Cyprus Plateau Mining Corporation
P.O. Drawer PMC
Price, Utah 84501
(801) 637-2875

ACT/007/006 # 2
Copy from
93A

Re: Application For Permit Change - Incidental Boundary Change -
Lease UTU-64263

FIGURE 4 - MAJOR HYDROGEOLOGICAL RELATIONSHIPS AND LOCATION OF COAL PROCESSING WASTE

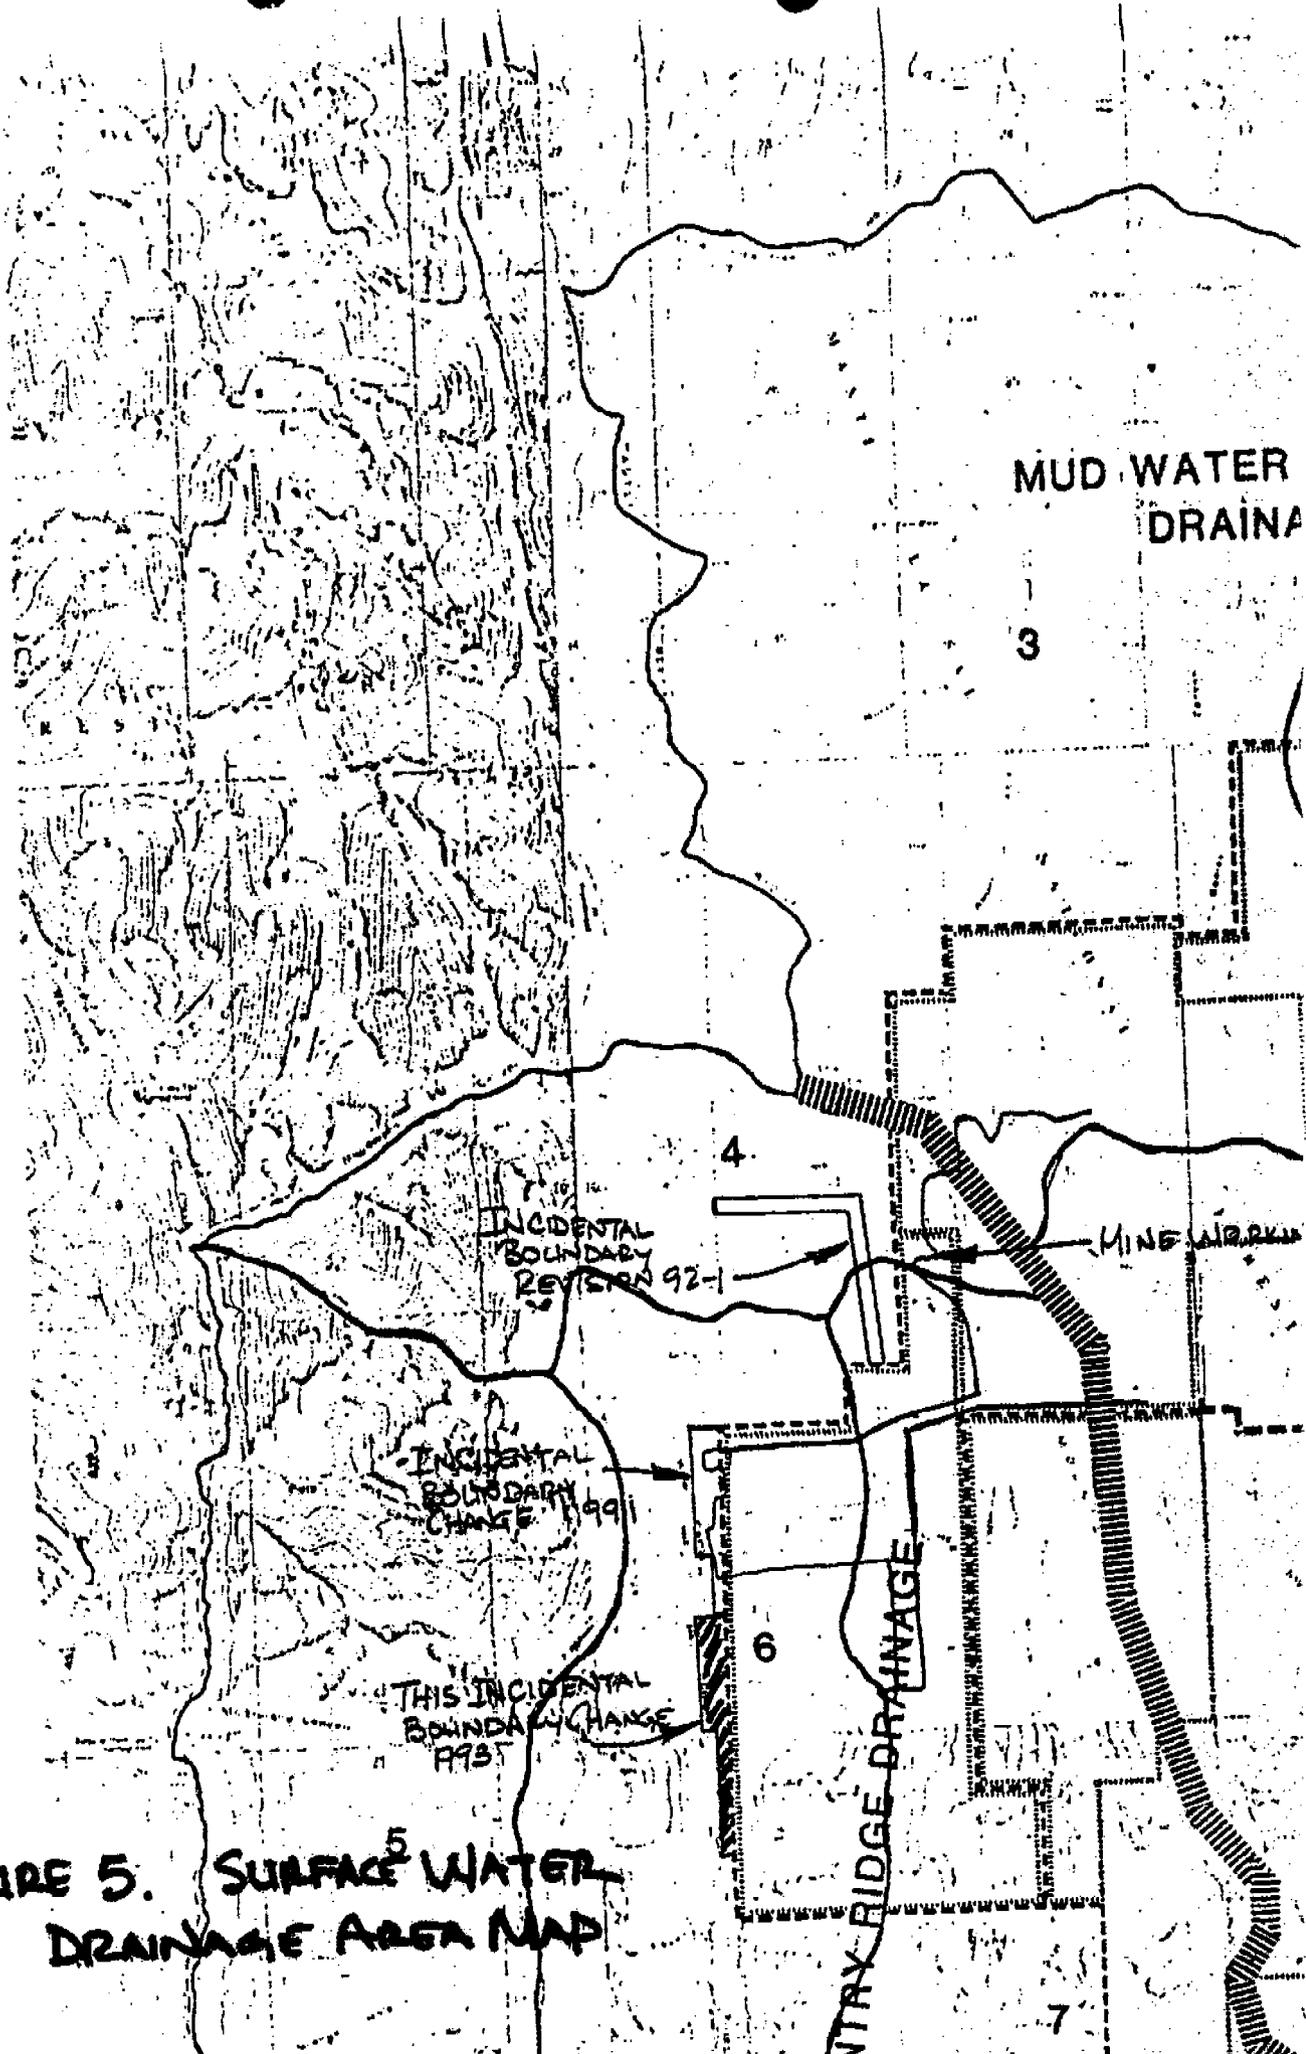
Figure 4 from the 1987 CHIA has been copied and the ground water surface elevations plotted based on the results from four new monitoring wells constructed in the mine. As can be seen, the water surface in the horst (the minable area) between the Bear Canyon Graben and the Trail Canyon Fault is oriented to the southeast just as the CHIA water surface predicted. The new water surface elevations have been colored on the map for clarity. The water surface elevation from our recent 1992 permit renewal application has been plotted on Figure 4 east of the Bear Canyon Graben. As can be seen, the new elevations in the horst match very closely with the elevations east of the Bear Canyon Graben. Even though the CHIA water surface elevations do not match ours, it is significant that the general orientation is the same, to the southeast. The CHIA needs to be updated with the latest information.
